Oconee Nuclear Station (ONS), Units 1, 2, and 3
Docket Numbers 50-269, 50-270, and 50-287
Renewed License Numbers DPR-38, DPR-47, and DPR-55

Subject: Response to NRC Request for Information associated with License Amendment Request to Add High Flux Trip for 3 Reactor Coolant Pump Operation
License Amendment Request No. 2014-05, Supplement 2

Enclosure: Duke Energy Response to NRC Request for Additional Information
Attachment: Calculation of Total Loop Uncertainty in the High Flux RPS Trip Function

FIGURE 1-1

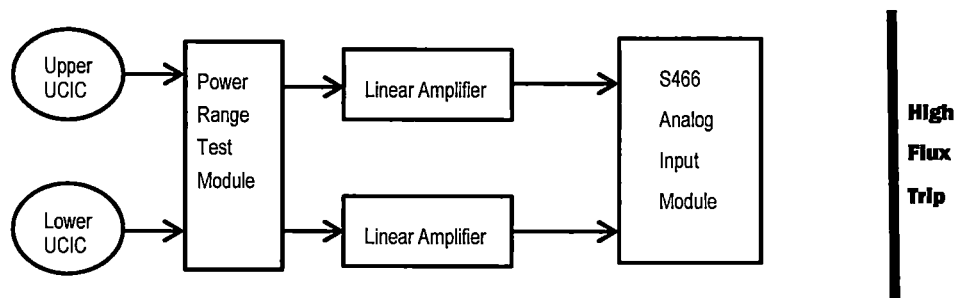
Please provide information (such as an uncertainty calculation) to demonstrate that instrument uncertainty has been accounted for in the establishment of this setpoint. The information provided should show how associated instrument Total Loop Uncertainty (TLU) was considered for the new setpoint.

This attachment provides the details of the TLU calculation provided in the response to RAI-03 of the enclosure to this submittal. The calculation is organized as follows: Section 1 contains the instrument block diagram of the RPS high flux trip function; Section 2 contains the RPS high flux reactor trip function uncertainty analysis; and, Section 3 contains the setpoint analysis.

Figure 1-1 shows a schematic block diagram of the high flux RPS reactor trip function instrumentation.

The signals (corresponding to the measured neutron flux) from the excore neutron detectors (Westinghouse UCICs) are directed through a power range test module (see Note below) and linear amplifiers to a S466 Analog Input Module. Output from the module is used by the Teleperm software which sums/averages the signals from the top and bottom detectors to obtain the total measured neutron flux signal.
